STATE OF NORTH CAROLINA  
DEPARTMENT OF TRANSPORTATION

SUBJECT: **Revision Request for Section 404 Regional General Permit No. 31 and Section 401 General Water Quality Certification No. 3886** for the proposed Interstate 85 (I-85) Widening and Interchange Improvements from north of NC 73 (Davidson Highway / Exit 55) to north of SR 2180 (Lane Street/Exit 63), Cabarrus & Rowan Counties, Divisions 9 and 10. Federal Aid Project No. FANHIMF-085-2(61)55, TIP Project No. I-3802A.

Revisions have been made at Sites 7, 7A, 14, and 22. Below are descriptions of the revisions at each of these sites. In addition to this cover letter, please find enclosed revised Wetland and Stream Permit Drawing Sheet Nos. 15 – 20, 41 – 44, 71 – 74, and 126 – 128 of 128; and the revised Mitigation Acceptance Letter from the N.C. Division of Mitigation Services (DMS).

**PERMIT DRAWING  
SHEET 71 OF 128**

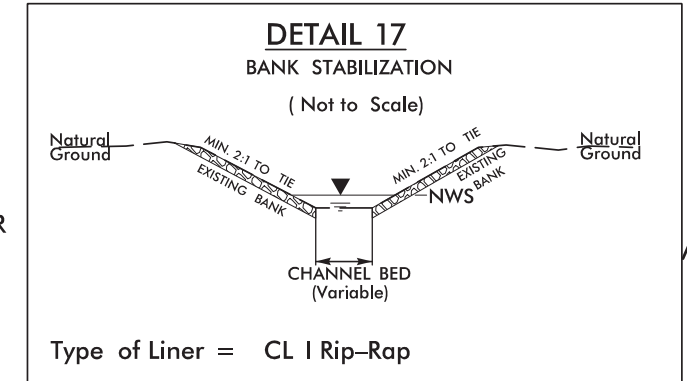
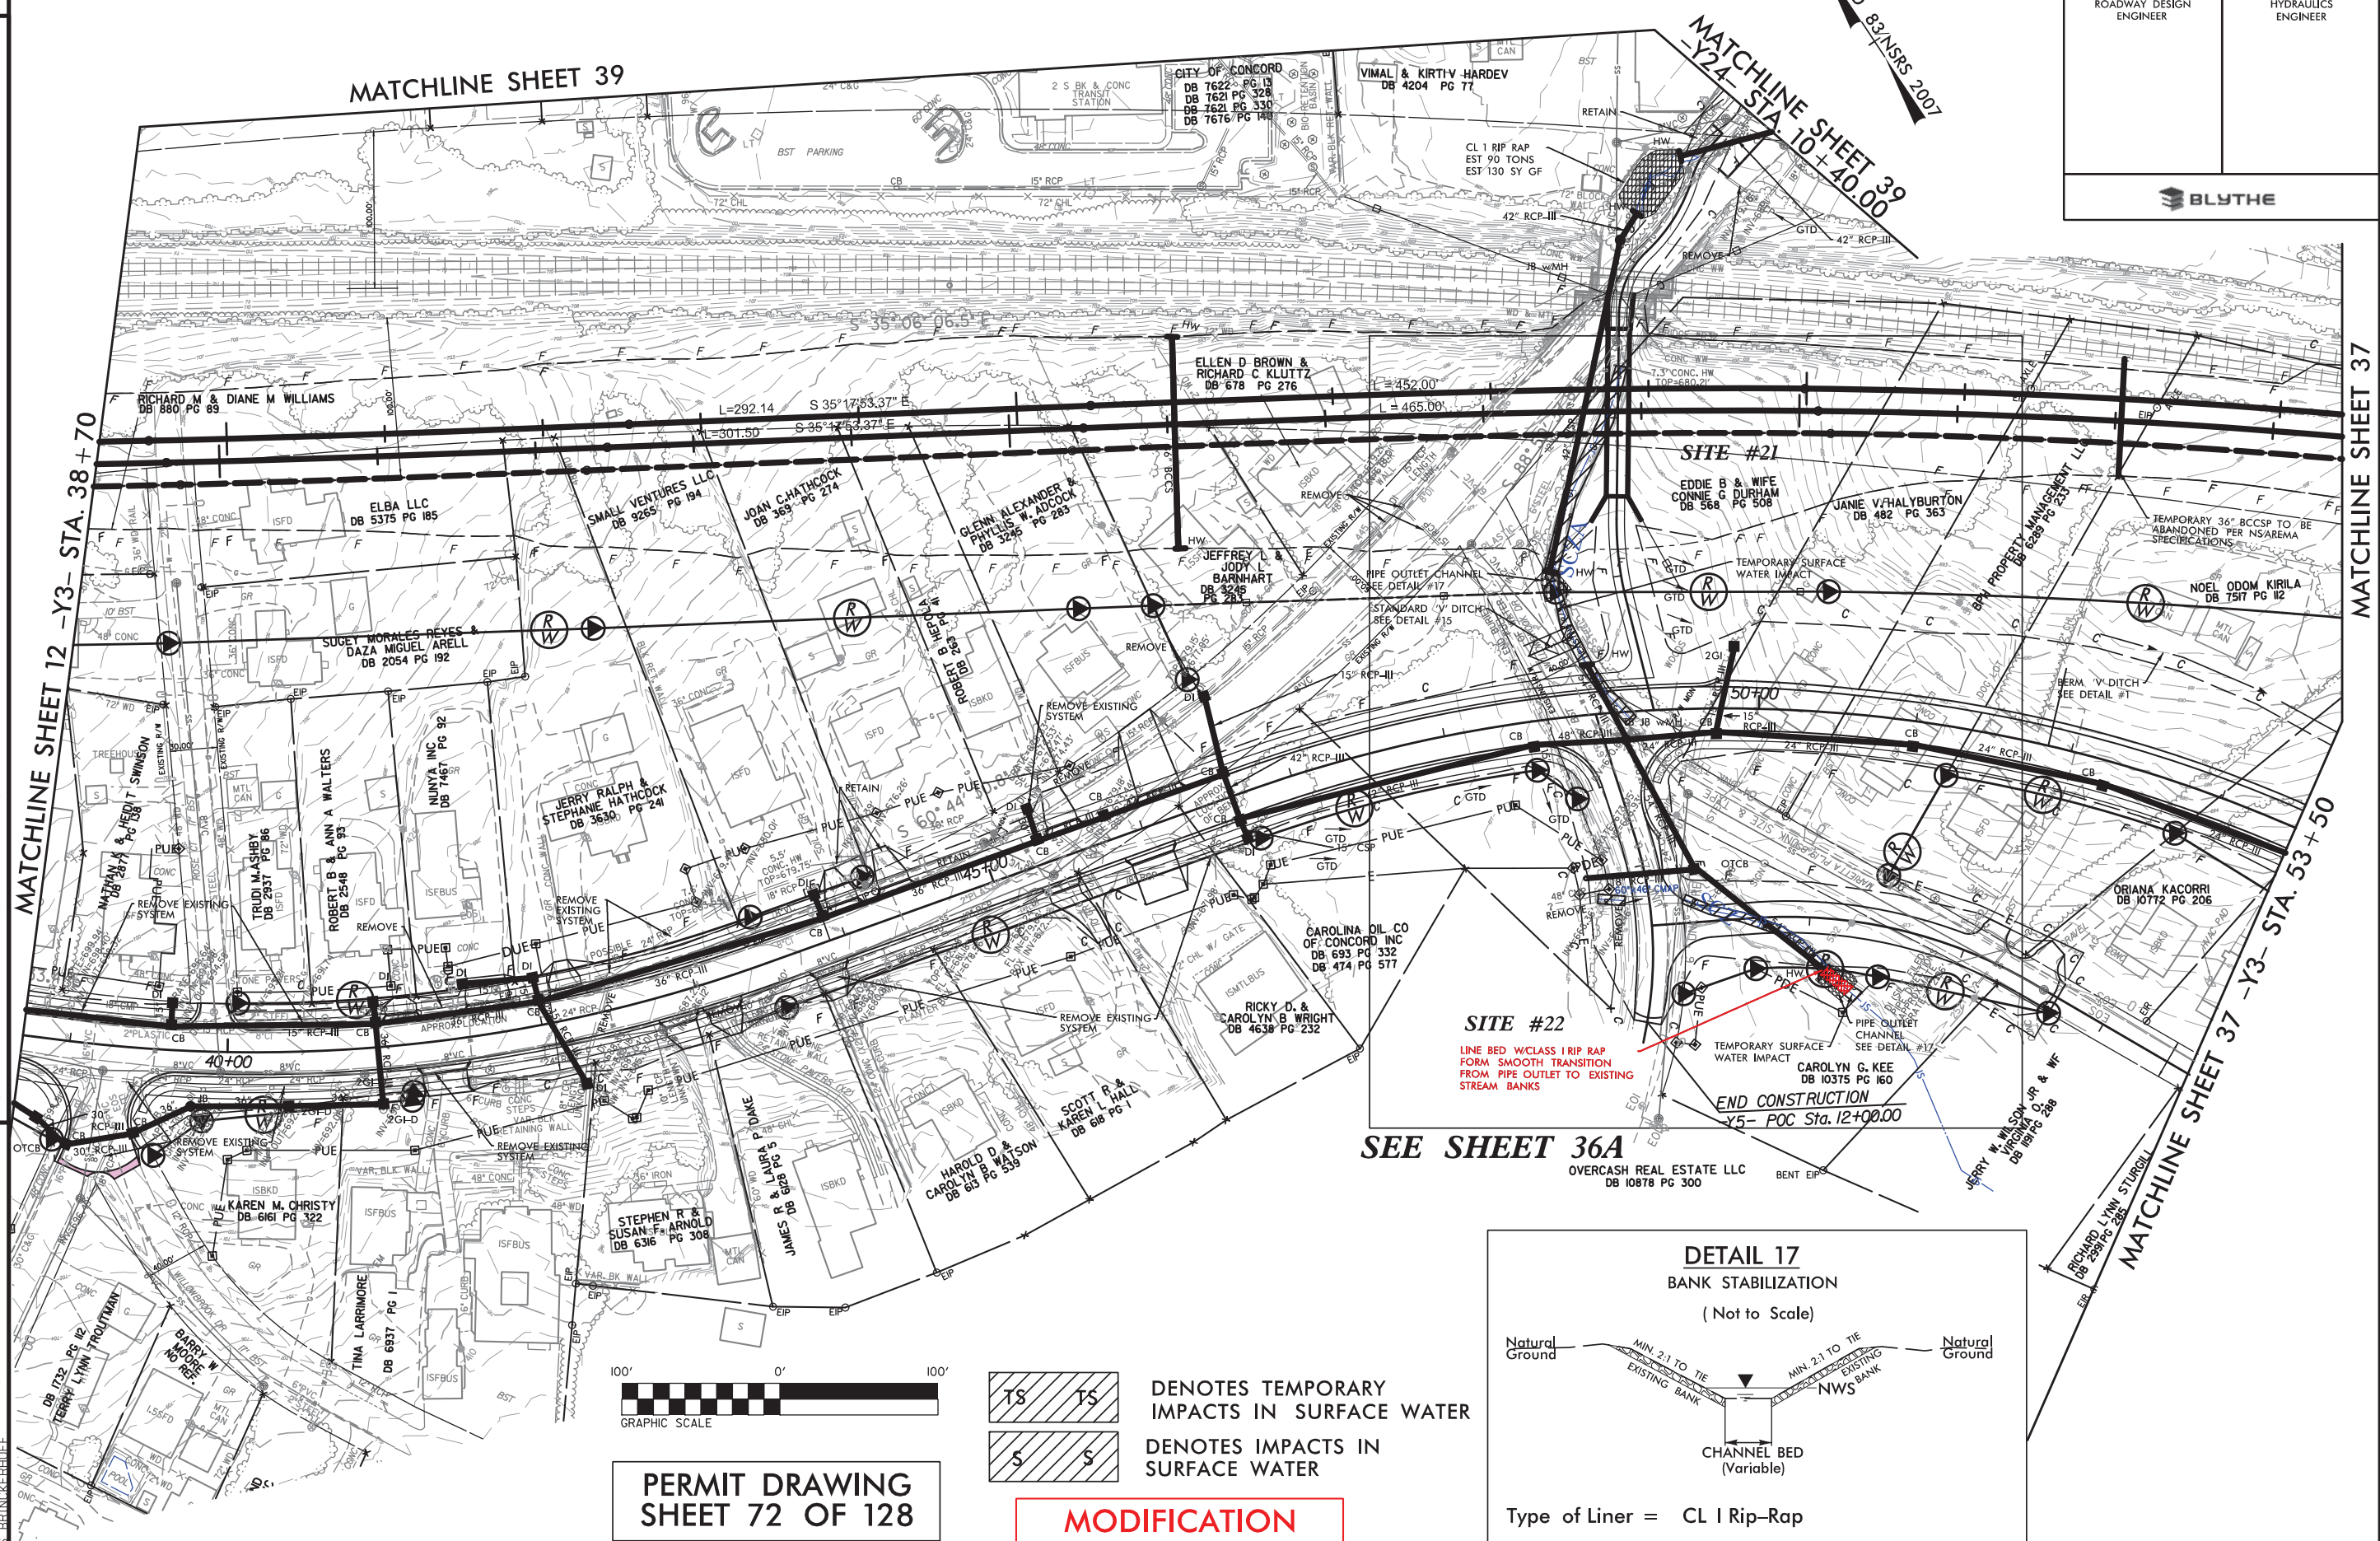
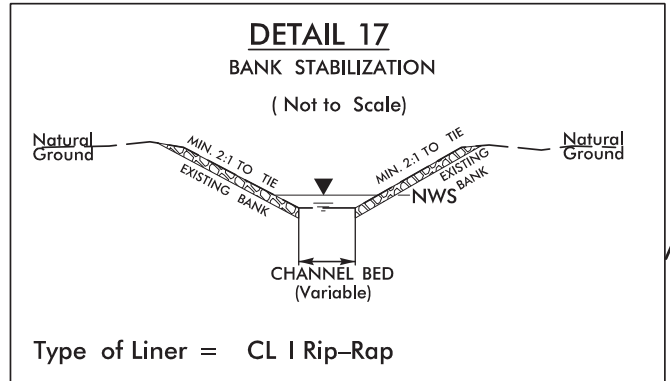
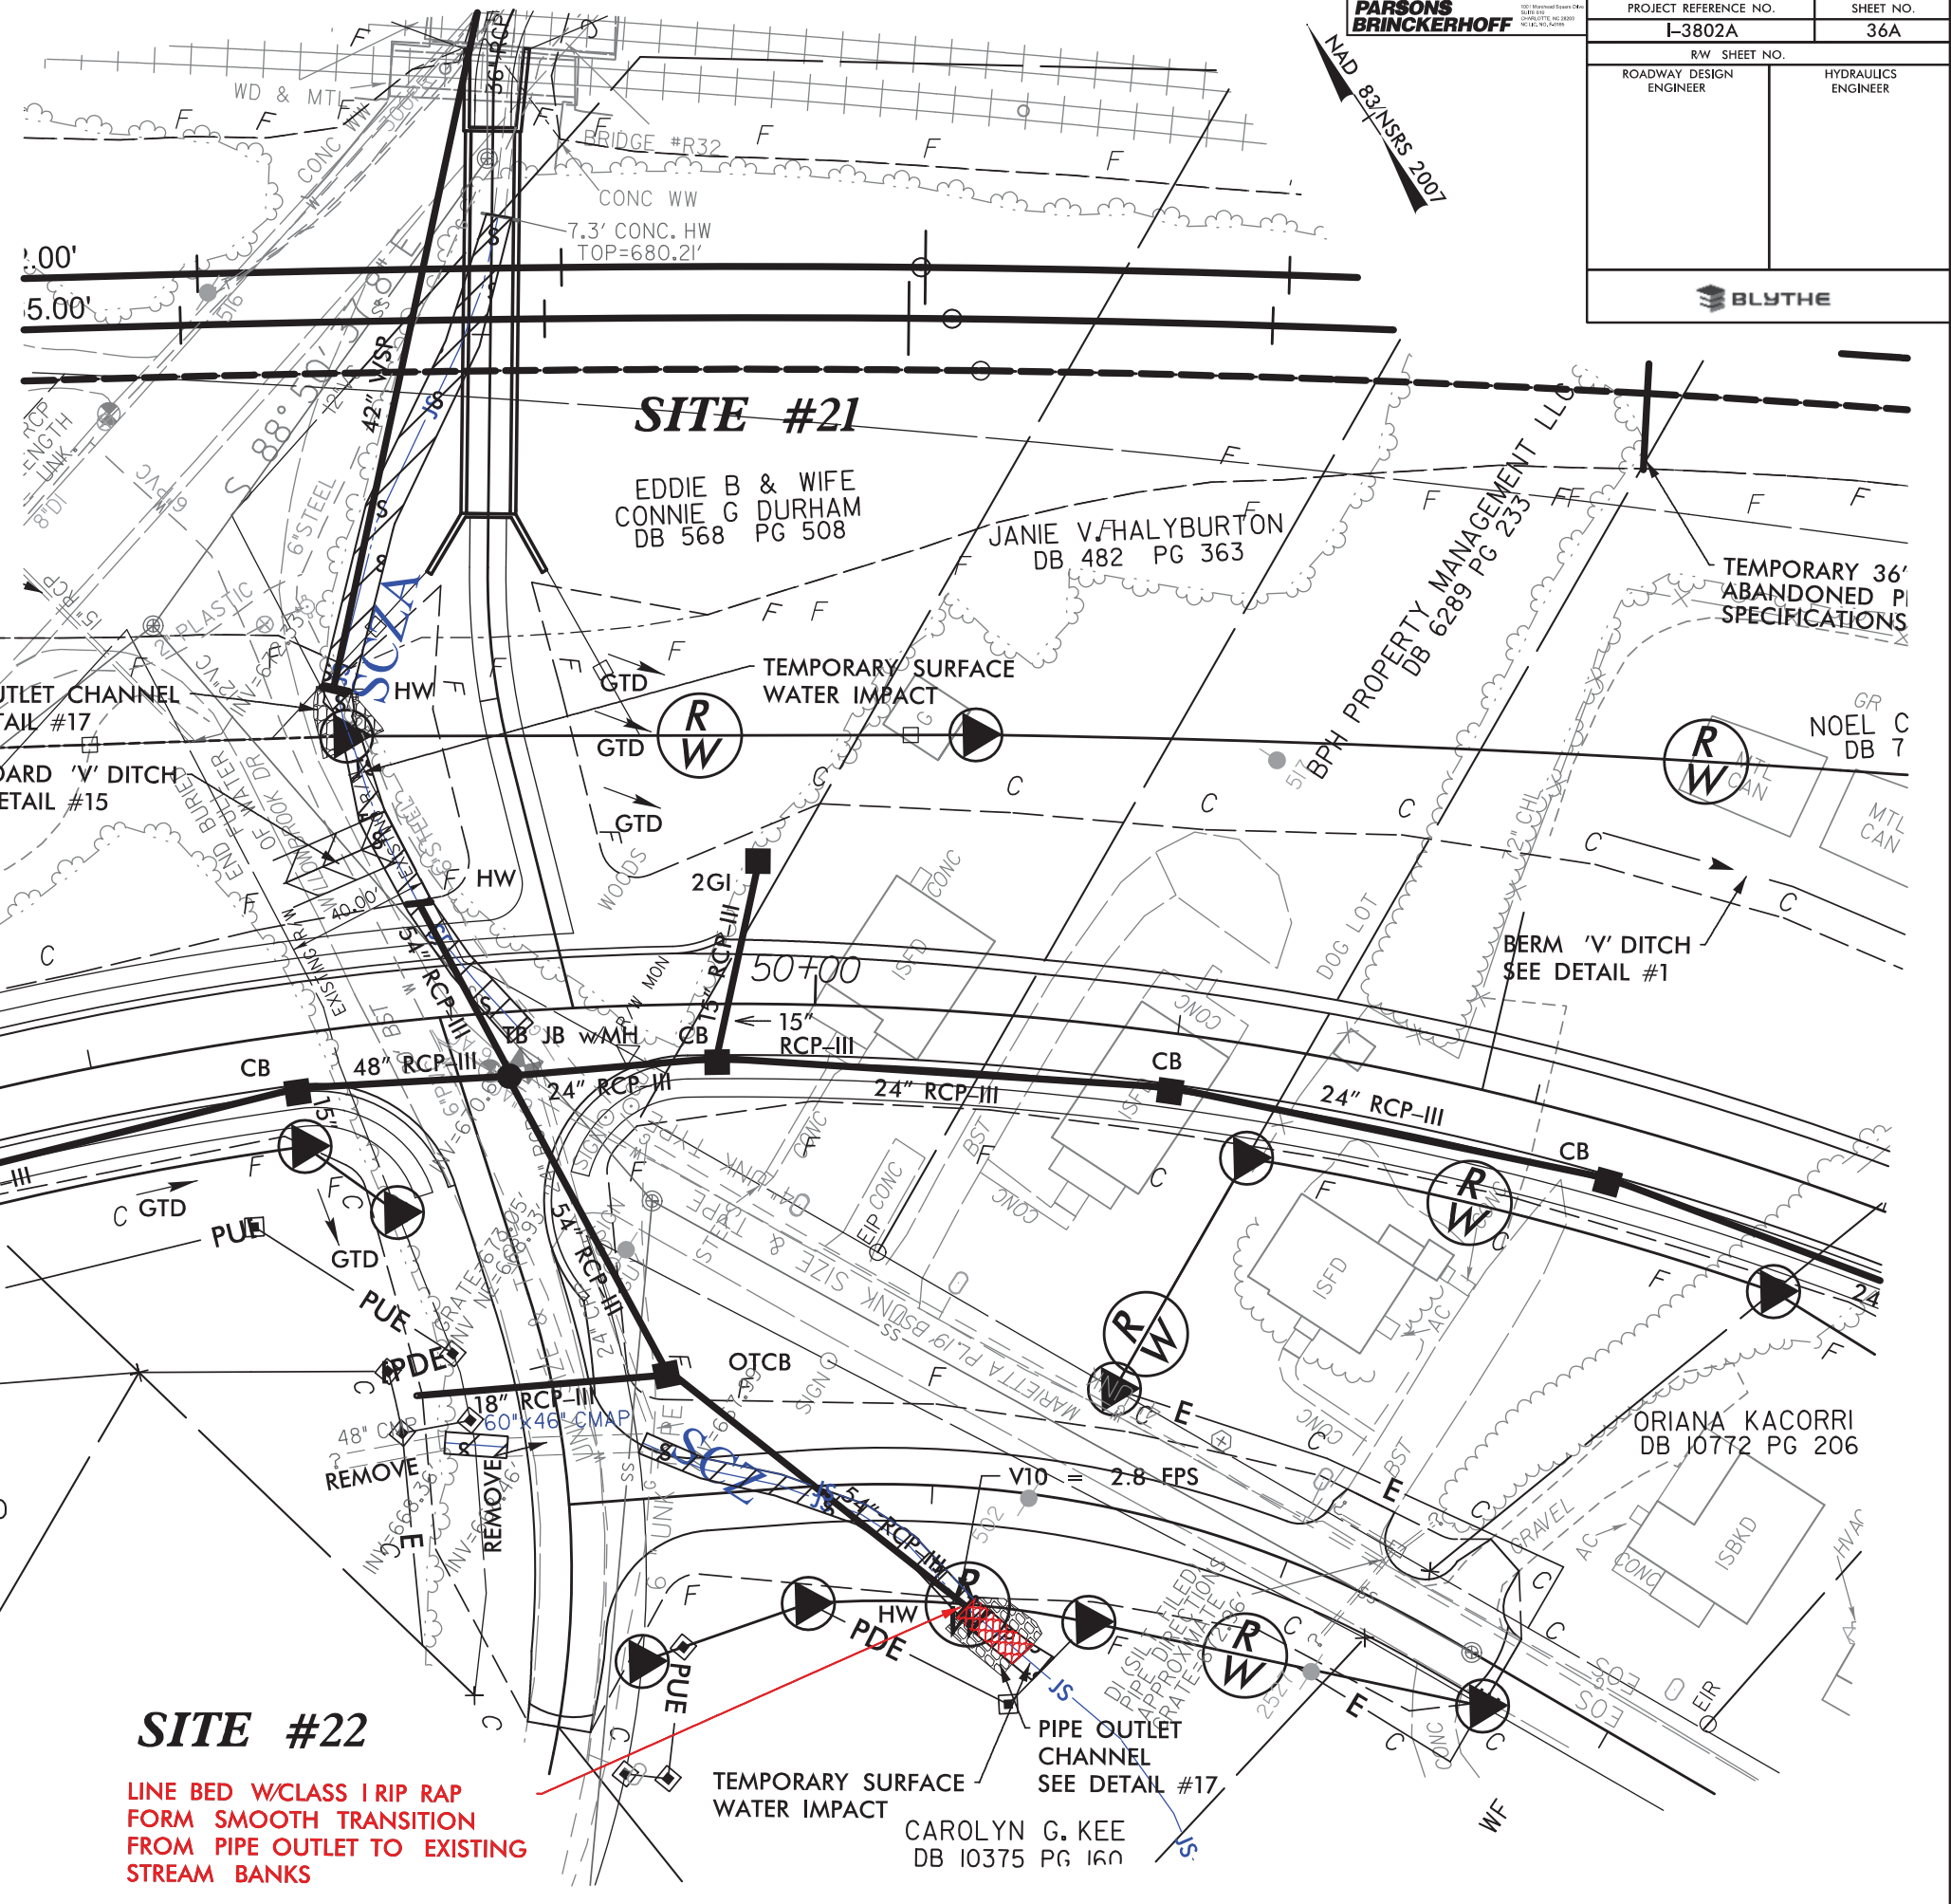
### *Wetland and Stream Permit Site 22 (Stream SCZ)*

Rip rap was added as outlet protection in the stream bed. The amount of impacts were not changed, but the description was changed from Bank Stabilization to Outlet Protection in the summary. Therefore, there was an increase in permanent fill of 15 linear feet, from 130 linear feet to 145 linear feet, and a reduction in bank stabilization of 15 linear feet, which eliminated all bank stabilization at this site.

**SITE #22**  
LINE BED W/CLASS I RIP RAP  
FORM SMOOTH TRANSITION  
FROM PIPE OUTLET TO EXISTING  
STREAM BANKS

**SITE #22**  
LINE BED W/CLASS I RIP RAP  
FORM SMOOTH TRANSITION  
FROM PIPE OUTLET TO EXISTING  
STREAM BANKS
